**WIDEFIELD WATER AND
SANITATION DISTRICT**

2 MG ROLLING HILLS TANK

**SITE DEVELOPMENT PLAN
FINAL DRAINAGE REPORT**

**RE: Widefield Water and Sanitation District
2 MG Potable Water Tank
1041 Submittal – Drainage Letter
Address: TBD (Schedule 5500000385)**

WIDEFIELD WATER AND SANITATION DISTRICT
ROLLING HILLS 2MG POTABLE WATER TANK AND INLET PIPELINE
CIVIL DETAILS

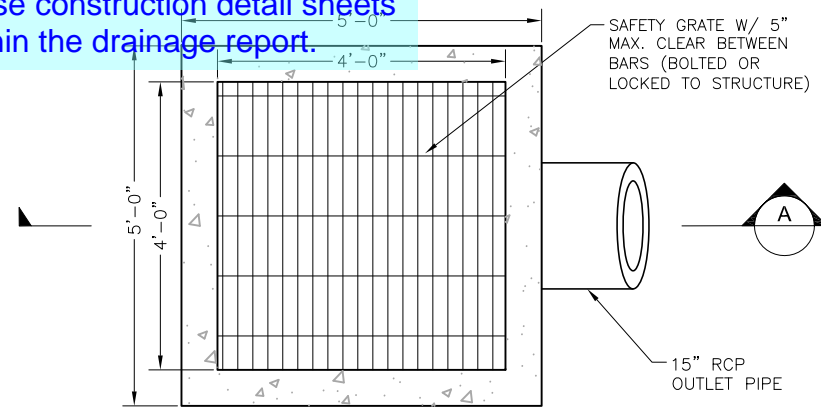
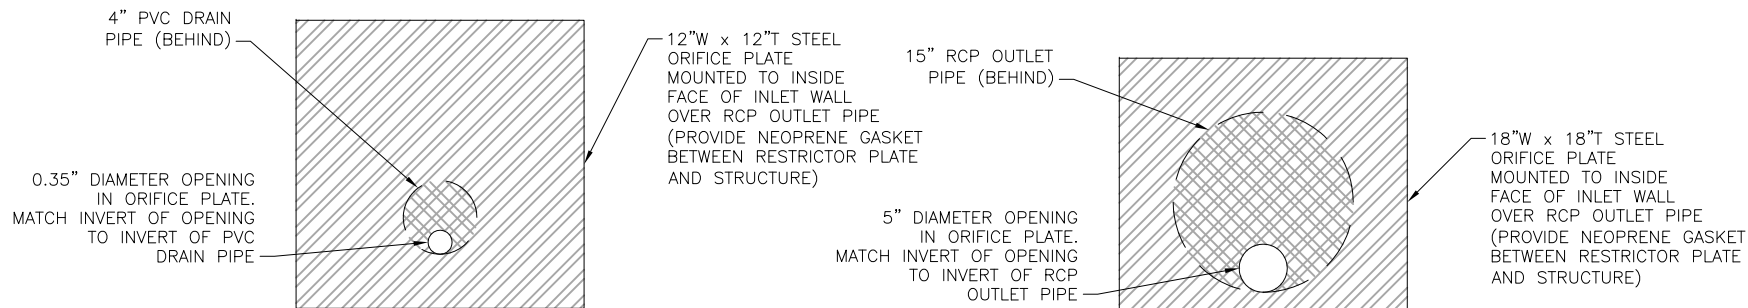
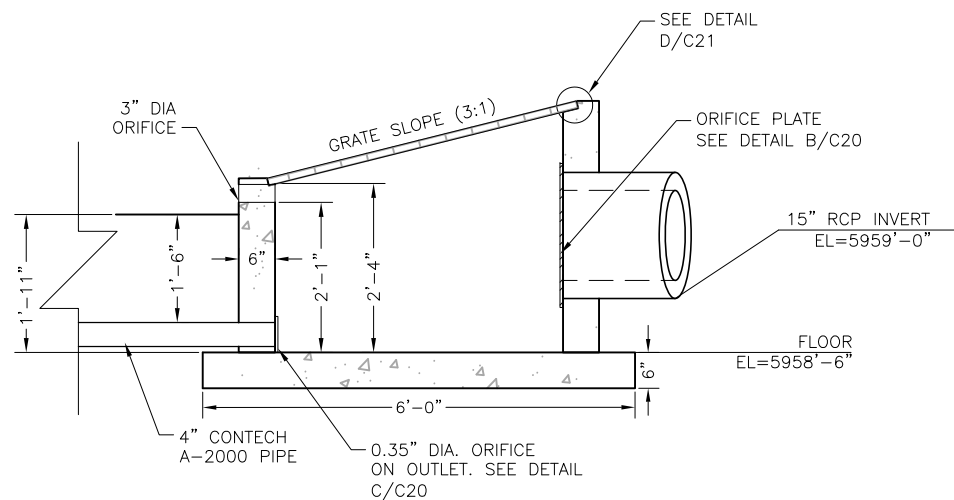
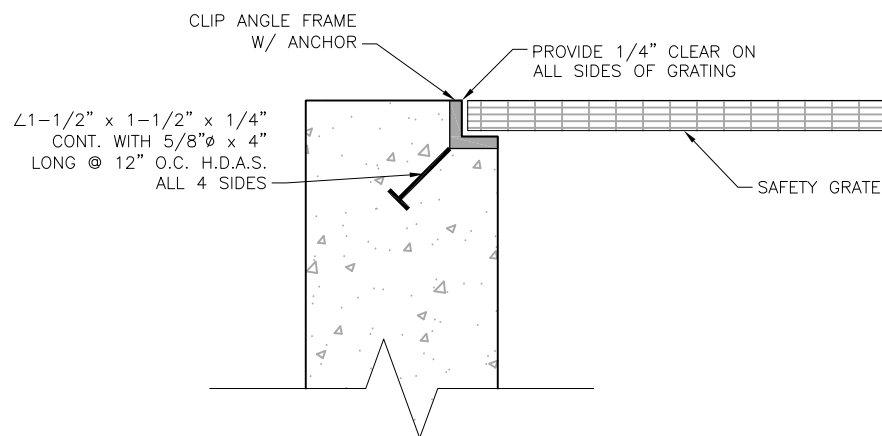
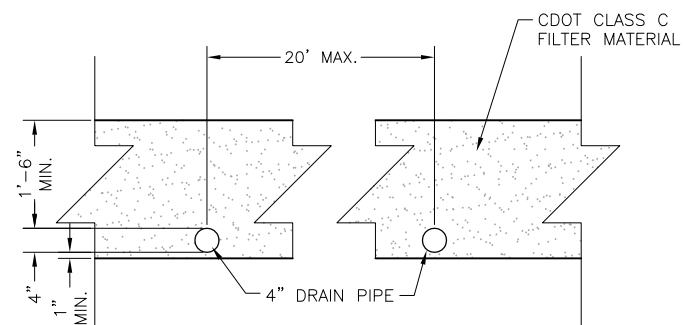
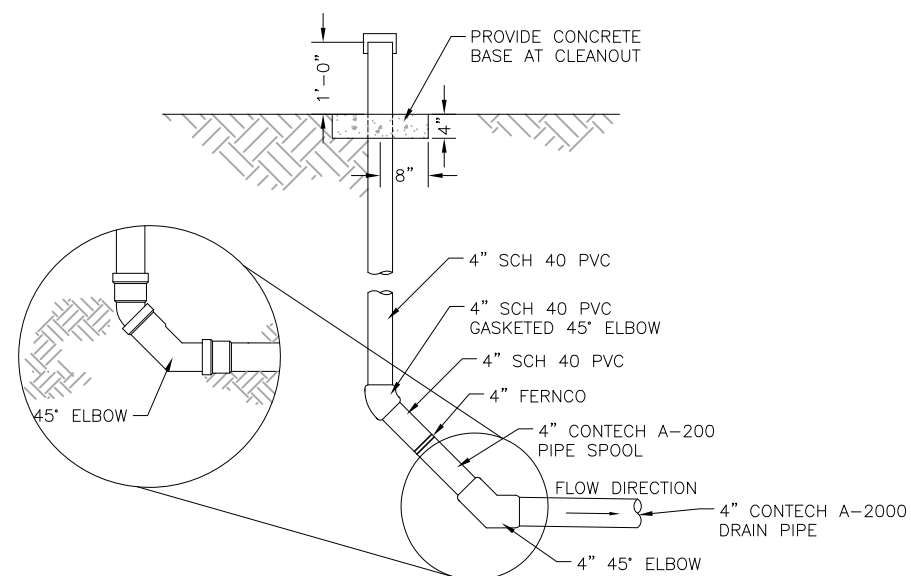
Please provide a note that indicates "for reference only" on these construction detail sheets within the drainage report.

A DRIVEWAY ACCESS ROAD
C22 SCALE: N.T.S.

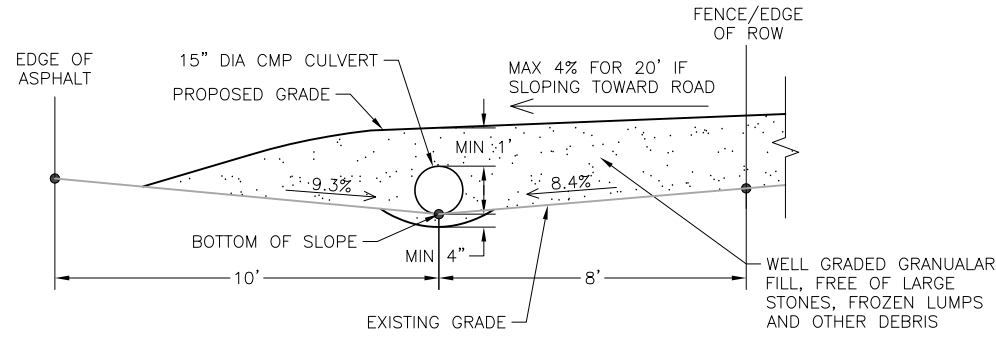
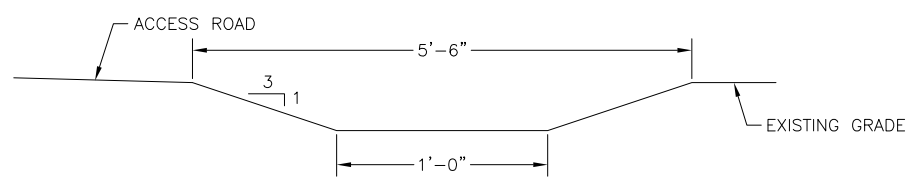
Please provide a note that indicates "for reference only" on these construction detail sheets within the drainage report.
